RECEIVED
WELL LOCATION AND ACREAGE DEDICATION PLAT

1 API Number 30-015-44489	2 Pool Code 97869	3 Pool Name SWD; Devonian-Silurian
4 Property Code 319766	5 Property Name FREEDOM 36 STATE SWD	6 Well Number 1
7 OGRID NO. 215099	8 Operator Name CIMAREX ENERGY COMPANY	9 Elevation 3387'

Subject: Freedom 36 State SWD #1 – SHL change
30015-44489
Sec. 36, 24S, 26E – Eddy County, NM

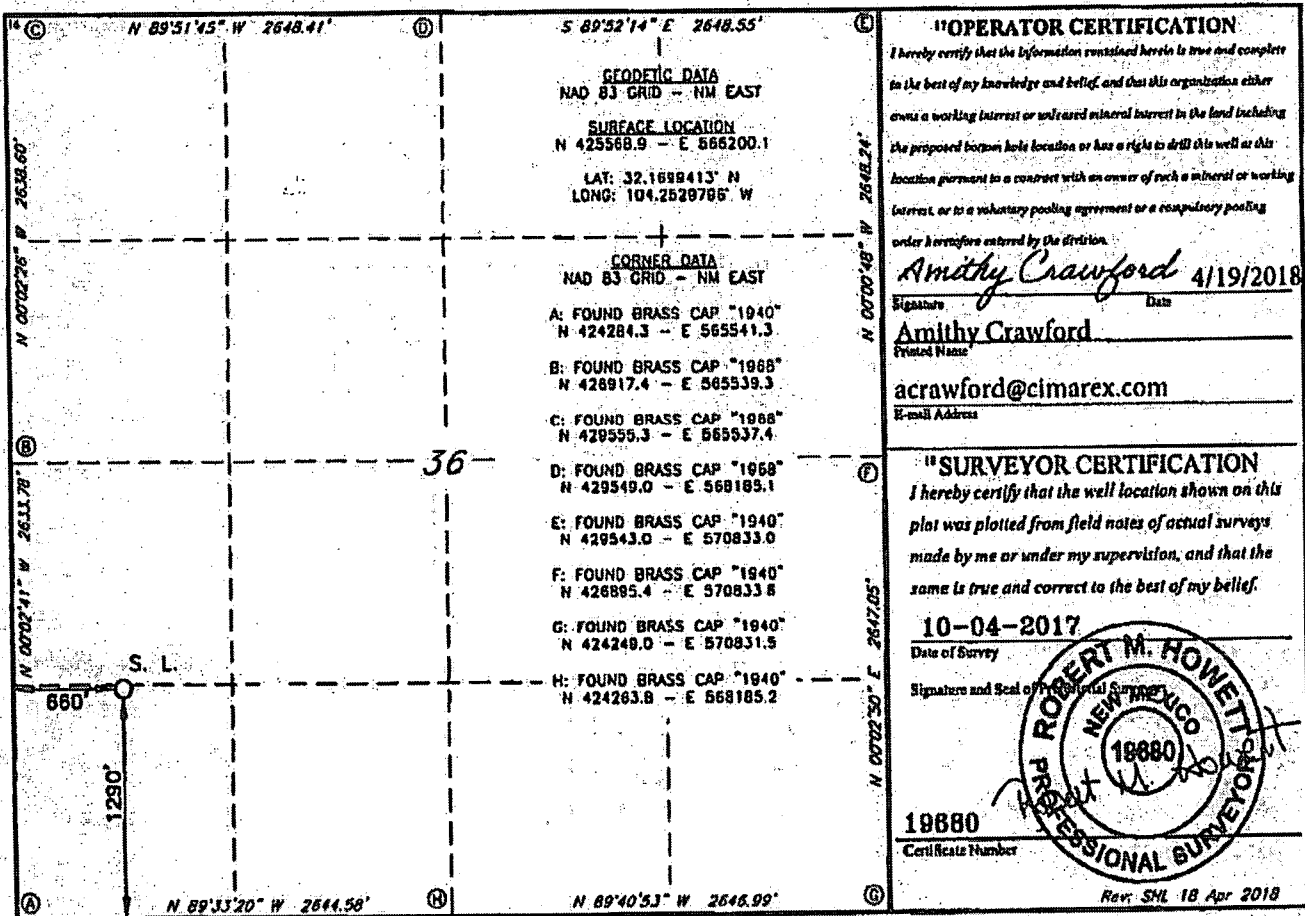
Cimarex Energy Co. requests approval to move the Freedom 36 State SWD #1 surface hole location as indicated below:

Proposed SHL: 1290' FSL & 660' FWL, Sc. 36, 24S, 26E – Eddy County, NM.

Cimarex set 20" conductor pipe instead of the necessary 30" conductor pipe when preparing the location for drilling. The proposed installation of the 30" conductor pipe will require a 10' move away from the permitted surface hole location to ensure no interference from the 20" conductor.
